SCHOOL BOARD OF LEE COUNTY AAAA PREK-8 SCHOOL

DEVELOPMENT ORDER (DOS2021-E004)

Village of Estero
PZDB Board Public Hearing
October 12, 2021

RESPONSE TO PZDB PUBLIC MEETING

NEW 'AAAA' PreK-8 SCHOOL

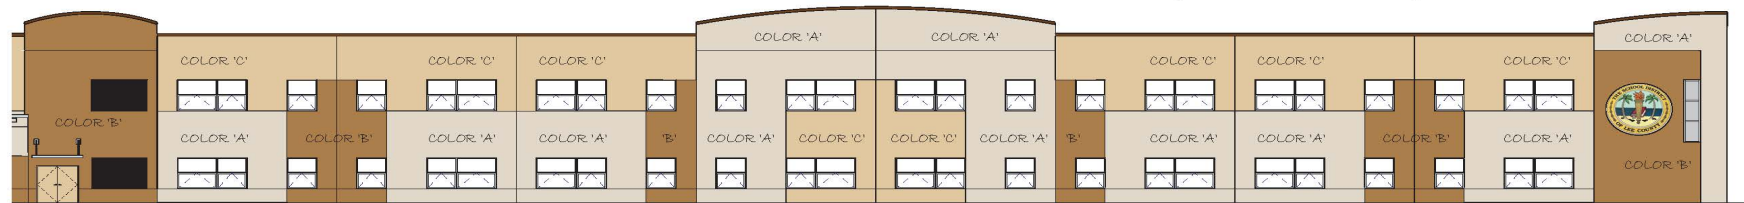
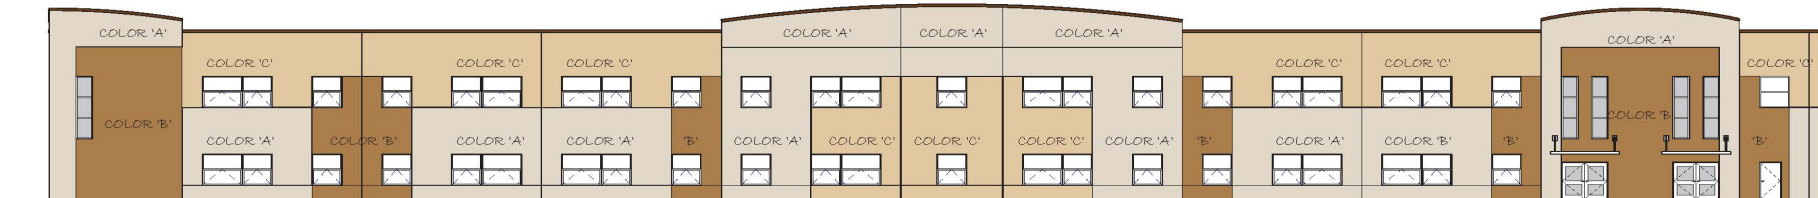
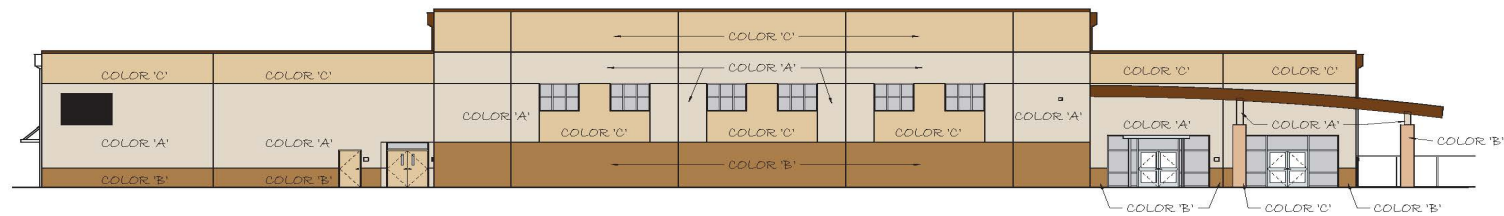
JUSTIFICATION - Response: Required styles are cost prohibitive to meet FI Statues and SREF cost caps. Responsible use of taxpayer dollars, and quality construction, is concrete tilt-up walls, with low-slope roofs and steel framed interior that provides 50+ year life span and future flexibility. **The School District agrees to enhance the western elevation to more closely align with the LDC as it is the only side visible from Three Oaks Parkway.**

JUSTIFICATION - Horizontal projections, especially for concrete tilt wall construction, creates multiple vertical joints and additional roof flashing conditions that lead to potential leaks which impact both the exterior envelope and interior environmental air quality. **The School District agrees to enhance the western elevation to more closely align with the LDC as it is the only side visible from Three Oaks Parkway.**

JUSTIFICATION - With flat roof construction, The School District can meet 2 of the 5 conditions, A. and D. The other 3 relate primarily to sloped roofs. **The School District requests to only meet 2 of the 5 requirements due to the proposed flat roof on the building. The School District also agrees to enhance the western elevation to align with the LDC more closely as it is the only side visible from Three Oaks Parkway.**
